# SERVICE BULLETIN

## UPGRADE OF 40-97E WHEEL ASSEMBLY TO 40-97F CONFIGURATION

**EFFECTIVITY:** Parker P/N 40-97E Wheel Assemblies equipped with Grease Seal Felt P/N 154-00300 and Grease Seal Rings P/N 153-00400 on Inboard Wheel Half.

**APPLICABILITY:** 40-97E Main Wheel Assemblies for use on Socata Model TB9, TB10 & TB200 aircraft equipped with Trailing Arm Landing Gear.

Figure 1 - Converting 40-97E Wheel Assembly to 40-97F Configuration

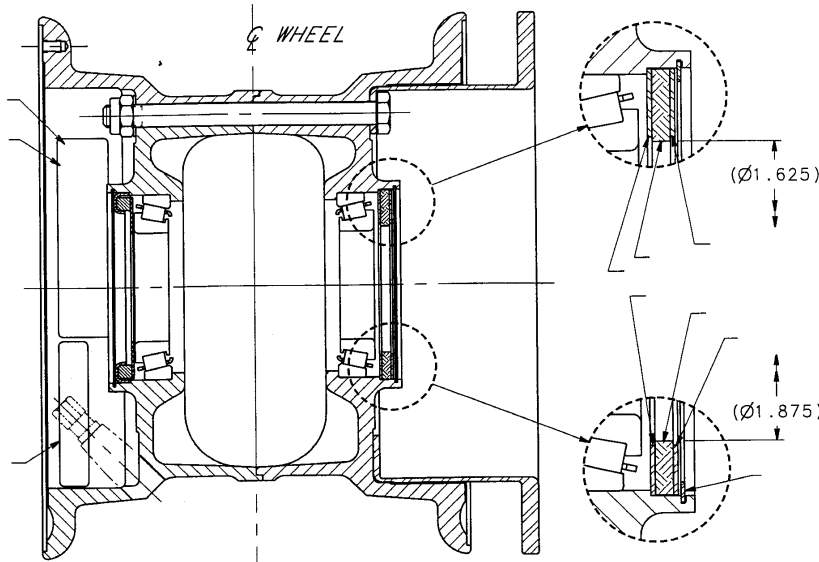
**REASON:** Product Upgrade - To allow reconfiguration of the P/N 40-97E Wheel Assembly currently using a diameter 1.625 in. I.D. Grease Seal Felt on the Inboard Wheel Half to P/N 40-97F Wheel Assembly which will use a diameter 1.875 in. I.D. Grease Seal Felt on the Inboard Wheel Half. This upgrade will permit proper interface of the Wheel Assembly to Trailing Arm Gear designed for use on TB9, TB10 & TB200 aircraft.

1. The following components must be removed from the existing P/N 40-97E Wheel Assembly and discarded: (See Figure 1 for location of components)

<u>PARKER P/N</u>	<u>DESCRIPTION</u>	<u>QUANTITY</u>
155-00100	Ring, Retaining	1
153-00400	Ring, Grease Seal	2
154-00300	Felt, Grease Seal	1
166-02100	Nameplate (located on Outboard Wheel Half)	1

2. Prior to installing new Grease Seal Rings and Grease Seal Felt on Inboard Wheel Hub, lightly saturate the Grease Seal Felt, P/N 154-01600 with SAE10 oil.
3. Install Grease Seal Rings P/N 153-01600 and Grease Seal Felt P/N 154-01600 on Inboard Wheel Hub as shown in Figure 1 and secure with Retaining Ring P/N 155-00100.
4. Install new nameplate P/N 166-19700 on Outboard Wheel Half as shown in Figure 1. Note: The manufacturing date code for all replacement nameplates will be coded with the current date that the nameplate is printed. Example: A nameplate that is printed in April of 1997 will be identified as Mfg. 04R97 (An "R" between the month and year indicates that this is a replacement nameplate).
5. Install P/N 166-20000 "Warning" Nameplate adjacent to the valve.
